REPORT SUPPORTING A NON-MATERIAL AMENDMENT APPLICATION

41 Frognal
London
NW3 6YD

Ref: KSR/41FRG/NMA/01a

Date: 13th November 2019

Figure 1: Excerpt from planting plan submitted with application 2016/4558/P showing surface manhole cover and lightwell which prevent shifting of retaining wall return eastwards, away from T41

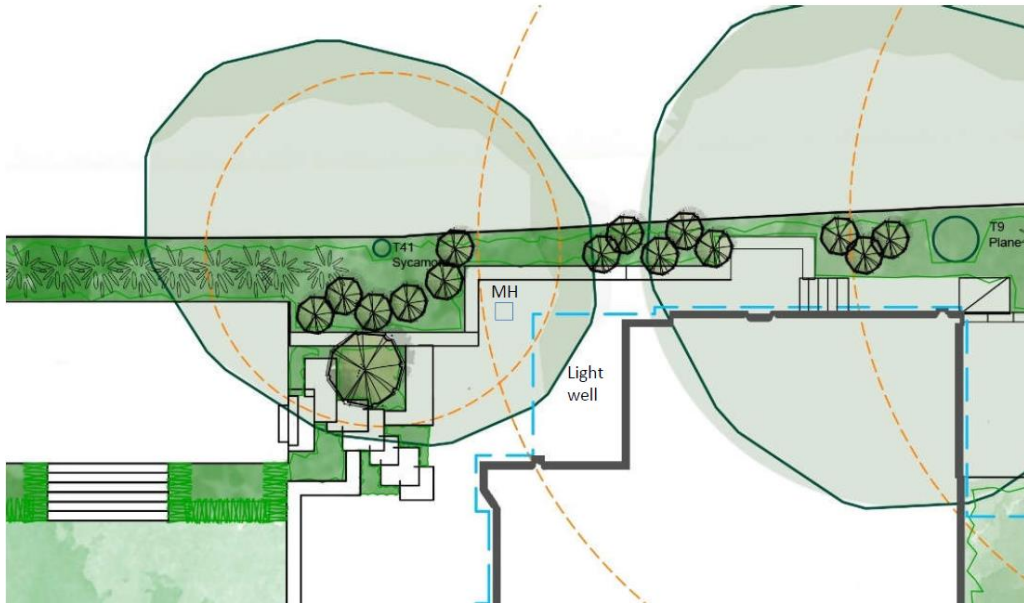
- 3.1 Figure 1 below shows the route of the retaining wall, particularly its return to the east of T41. It can be seen that the juxtaposition of the lightwell and surface manhole cover to the retaining wall return prevent the shifting of the return further eastwards away from the tree and therefore it is necessary to remove the tree. In order to allow the proposed planting in this area, the stump and major roots will be ground out as far as possible. Rather than leaving the arisings in place, they will be removed from site with the area backfilled with good quality topsoil in order to provide as good a rooting medium as possible. Replacement planting will be provided *in situ* and comprise a 4m feathered field maple.

Figure 2: Extract showing area of soil to be excavated to facilitate extension of bin store and sections of existing walls to be underpinned

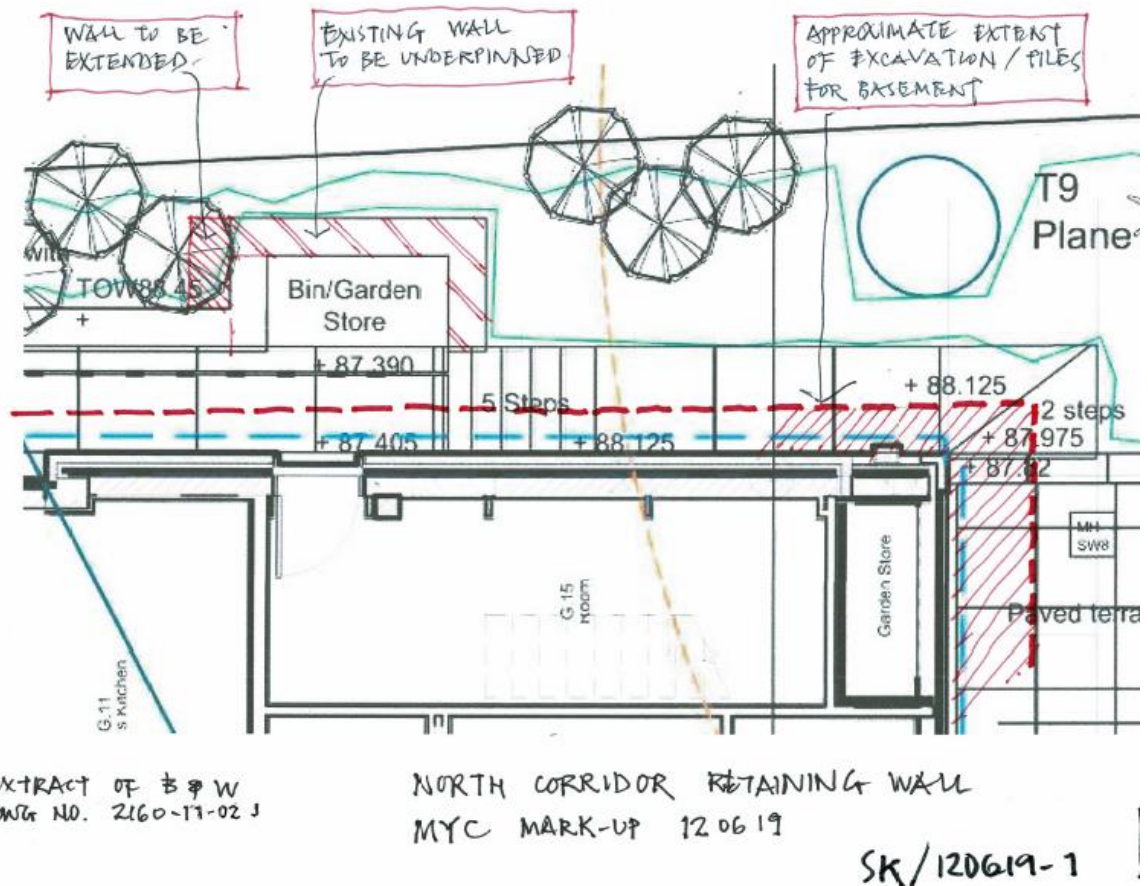
- 3.2 Figure 2 shows the area proposed to be excavated to extend the bin store and also where underpinning will be required. It is not anticipated that any significant roots will be encountered during the extension of the bin store due to its position on the far side of the existing construction from the tree. Notwithstanding this, the excavation of the outer limits of this area will be carried out manually under arboricultural supervision.

- 3.3 The underpinning of the existing walls will also be carried out manually under arboricultural supervision. Should significant roots be encountered whose severance would compromise the ongoing health and stability of the tree, they are to be retained with the foundations for the retaining wall (and attached steps) adapted accordingly.
